RE: JMC Project 20029  
Edward Jones Office  
150 Bedford Road  
Town of North Castle, NY

**Response to Town Comments Submission**

**Town of North Castle Planning Department, July 4, 2020**

**Kellard Sessions Consulting, P.C. Memorandum, dated July 9, 2020**

**NORTH CASTLE VETERANARY HOSPITAL**  
BEDFORD ROAD, ARMONK, N.Y.

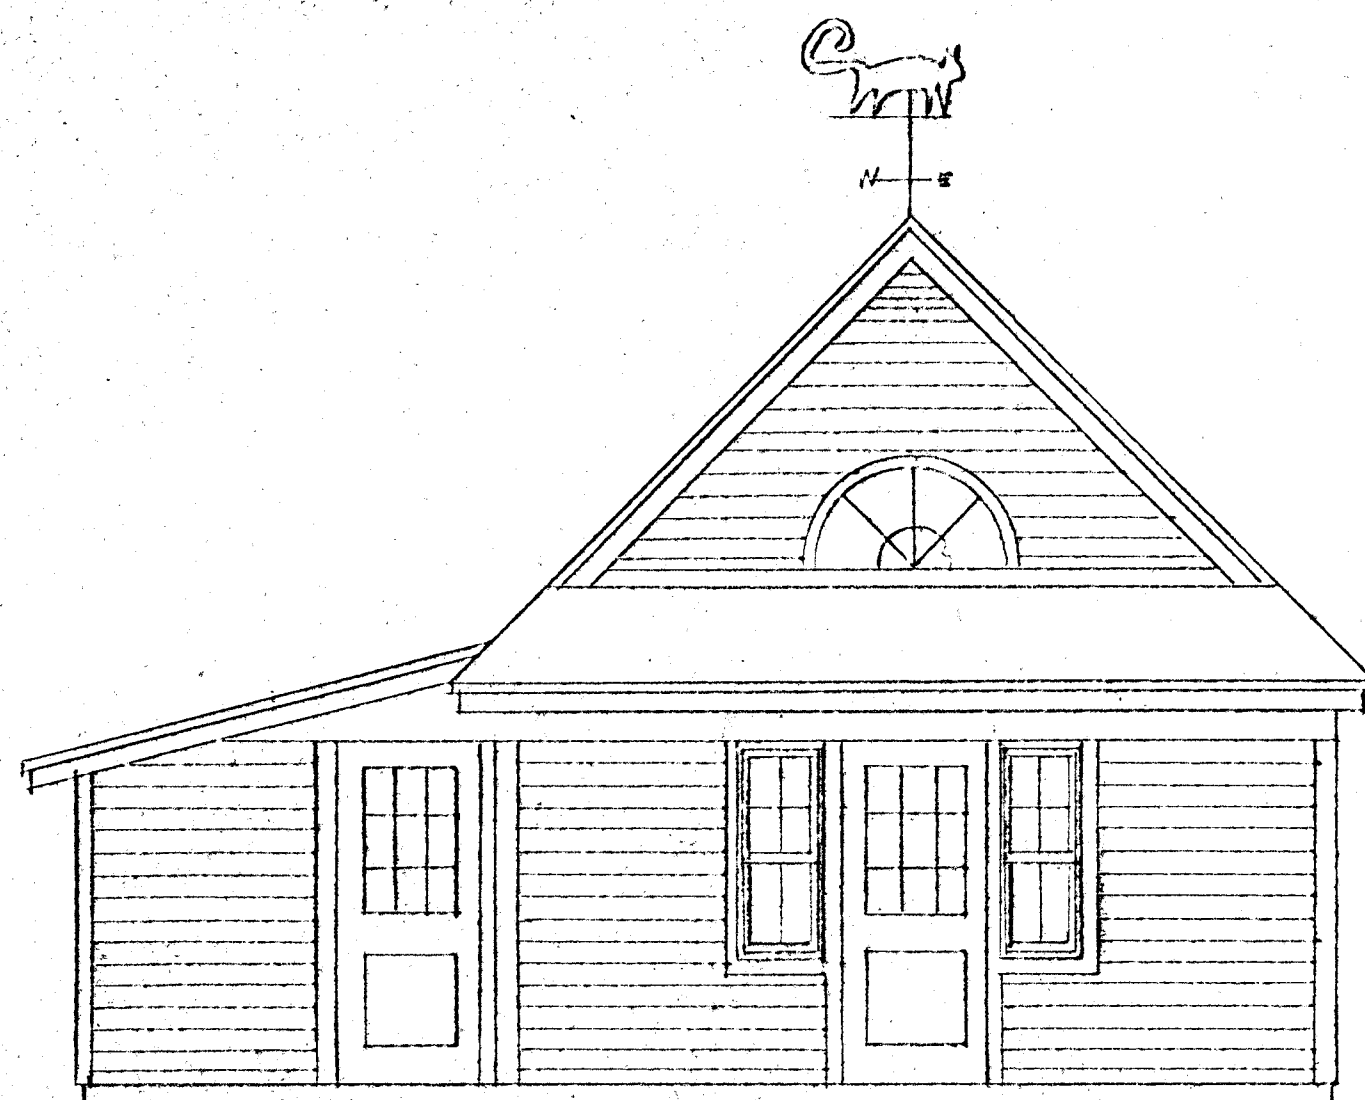
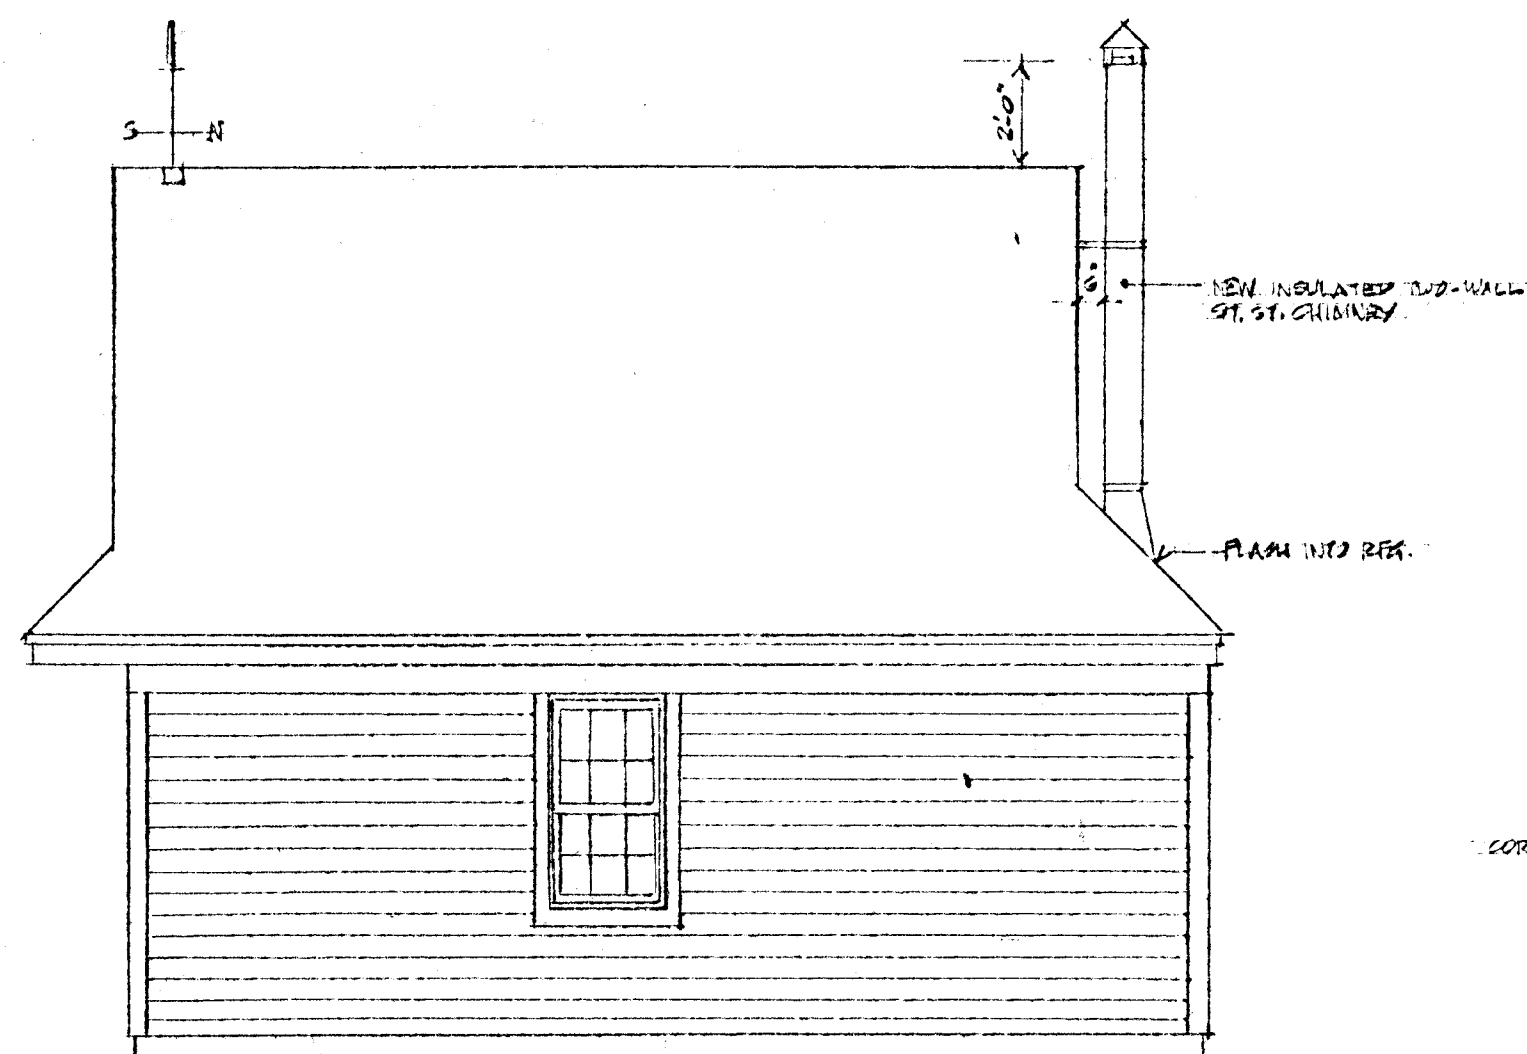
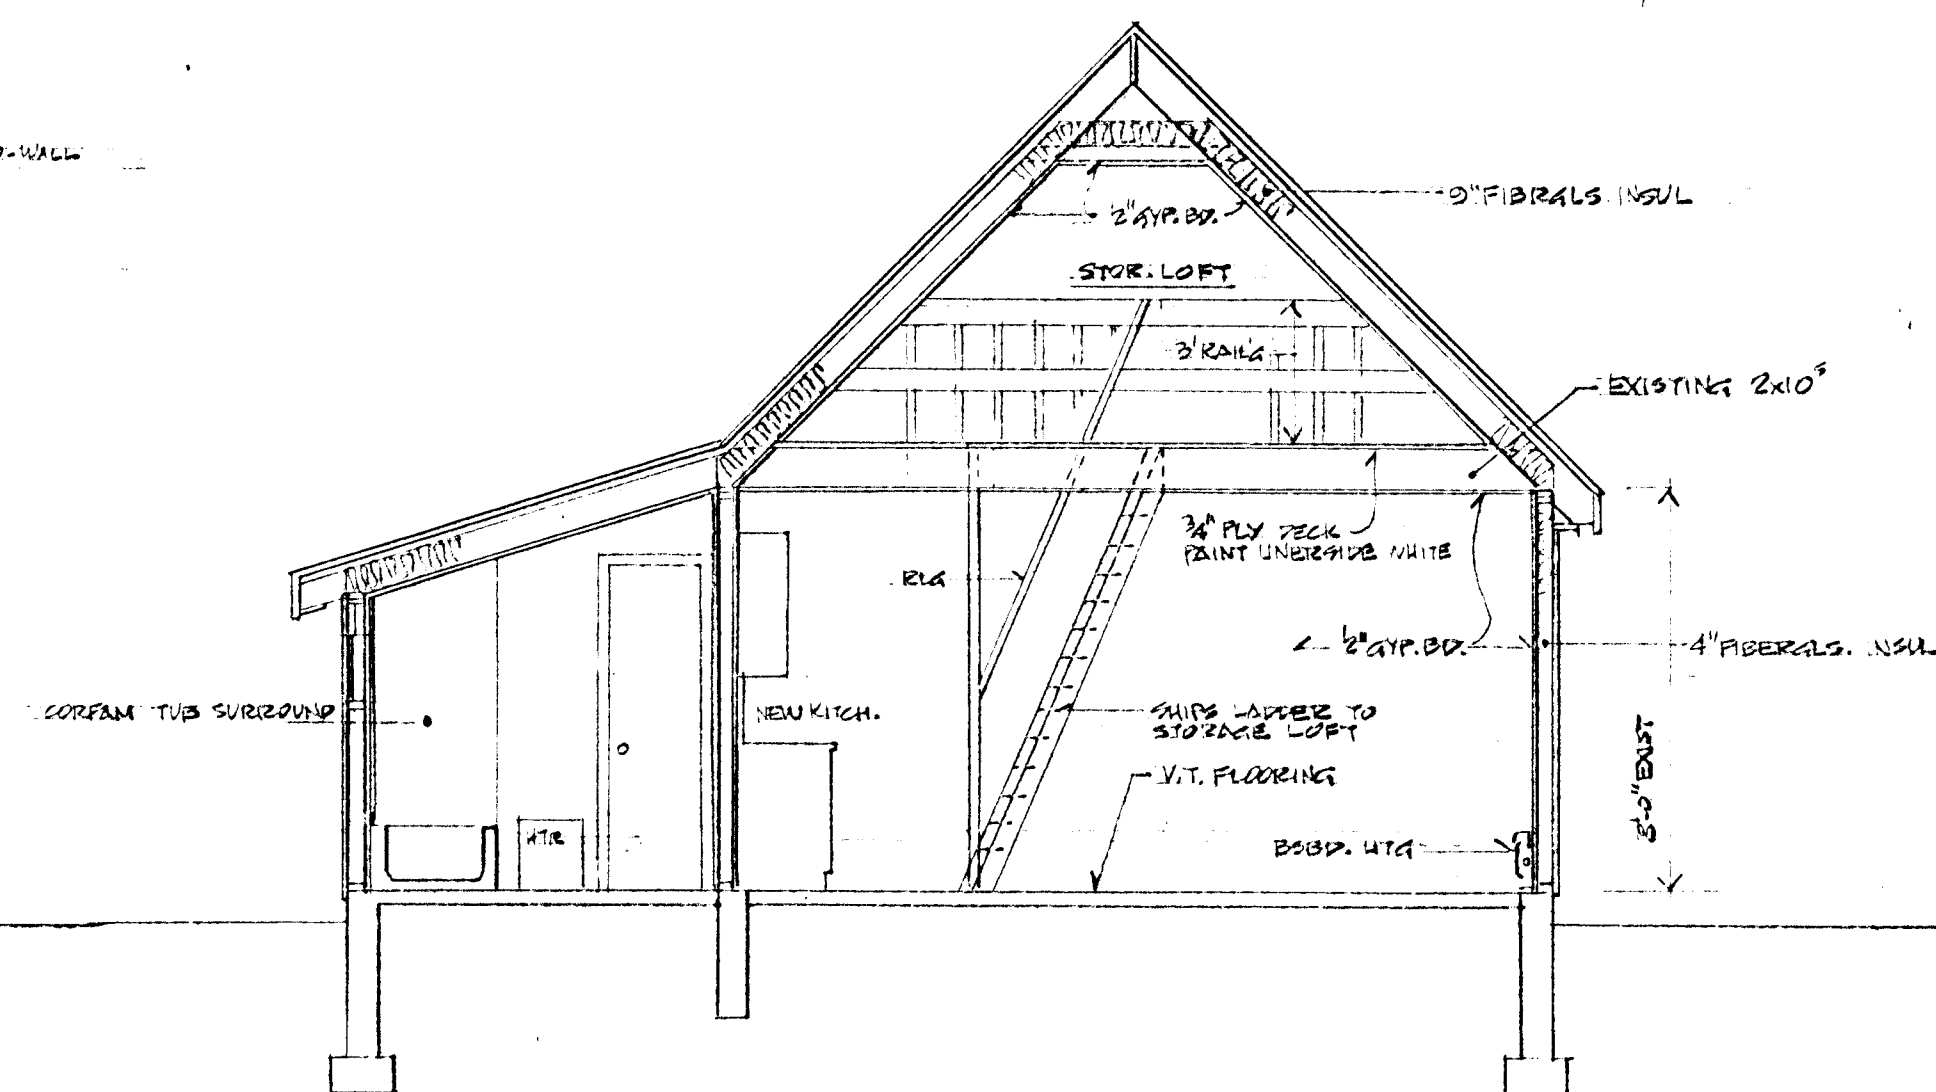
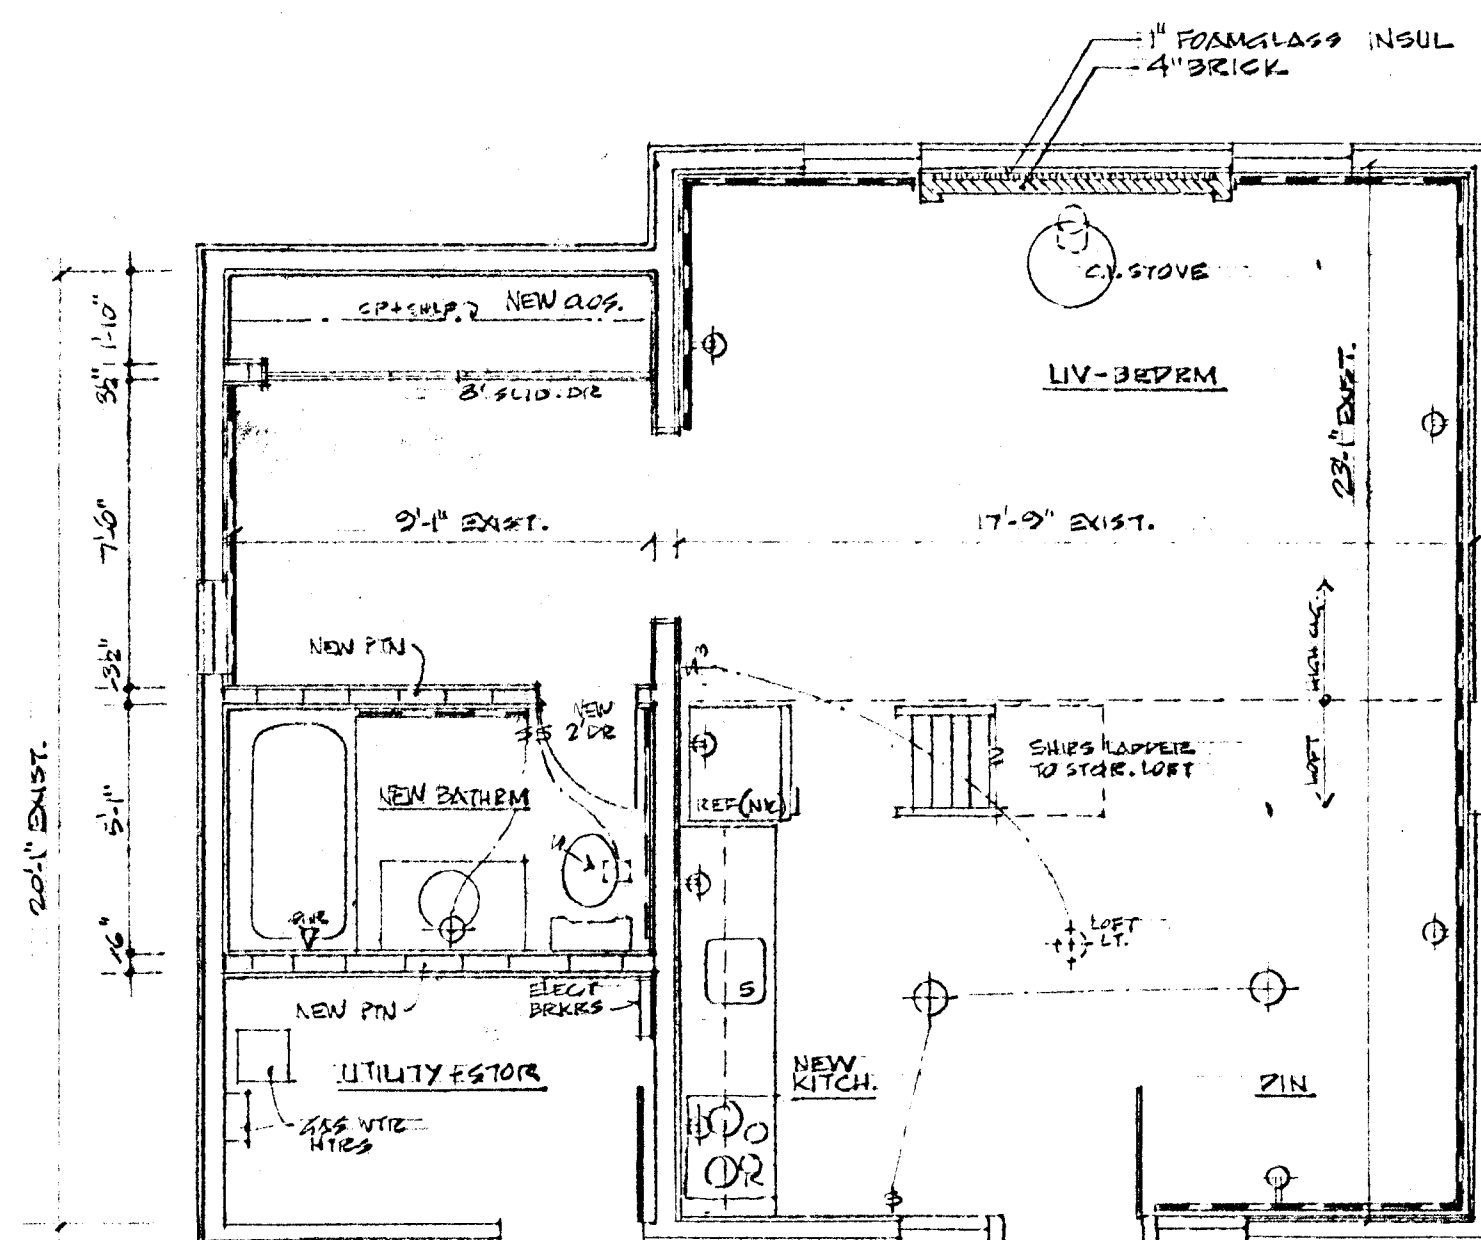
*The previously approved floor plans for the residence should be submitted and made part of the current record*

The previously approved floor plans for the existing residence have been included in this submission. Refer to drawing I of I "North Castle Veterinary Hospital", prepared by George Early-Architect, last revised 11/15/1988.
